MANDATORY SERVICE BULLETIN

NO. MSB20-047

Alteration of coolant to EVANS NPG+, Rotax SB-912-043, Rotax SB-914-029

CHANGE OF COOLANT SPECIFICATION ON ROTAX® ENGINE TYPE 912 AND 914 (SERIES)

The following drawings should provide additional information: See fig. 1

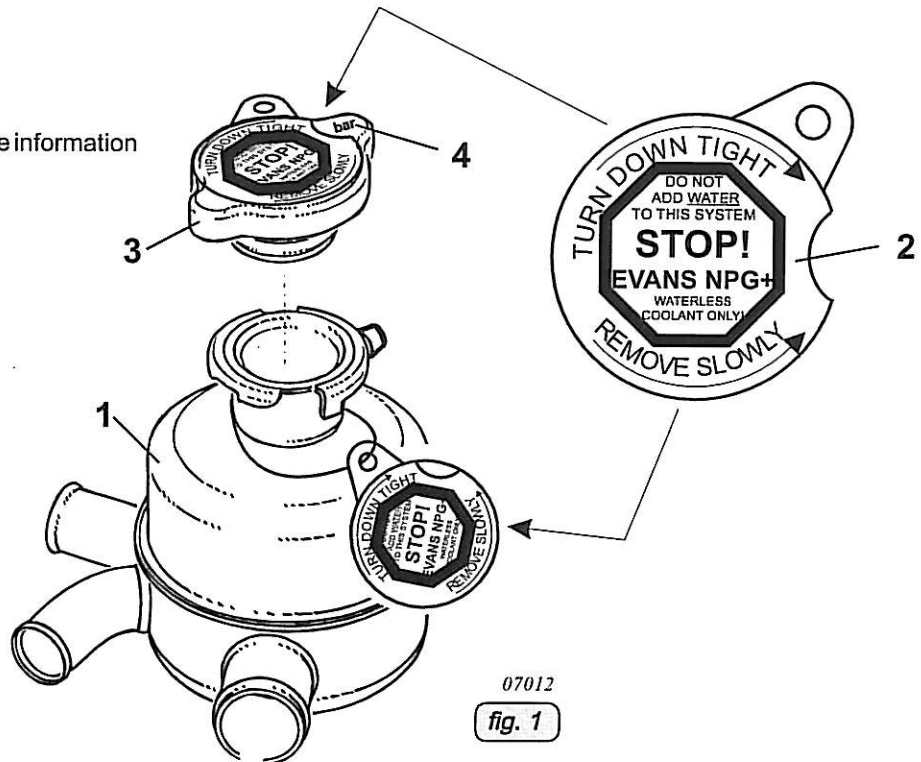
◆ **NOTE:** On the radiator cap (3), to identify the new coolant, the warning label (2) is to be affixed so that the opening pressure data (4) is visible.

- For new engine deliveries the sticker will be temporarily attached to the expansion tank.
- The sticker has to be affixed to the radiator cap in accordance to the aircraft manufacturer's instruction.

- 1 Expansion tank
- 2 Warning sticker
- 3 Radiator cap
- 4 Excess-pressure information
